HONDA **Service Bulletin** **15-012**

AWD Indicator Is On with DTC C1850-14

Year	Model	Trim	VIN Range
2012–14	CR-V	AWD	ALL with AWD

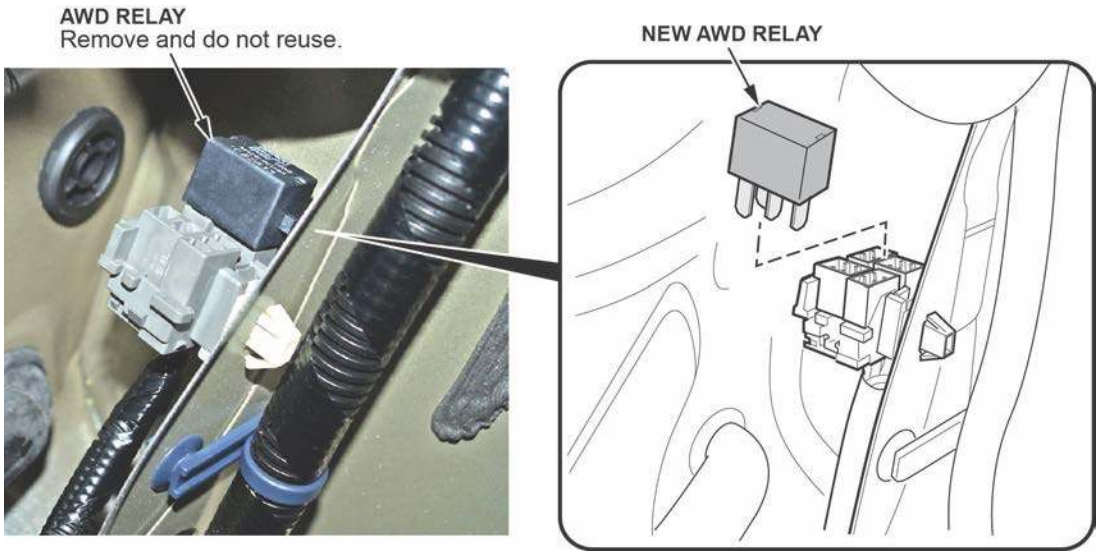
1. Find and remove the AWD relay (for details on how to do this, see the electronic service manual).

2. Replace the AWD relay.
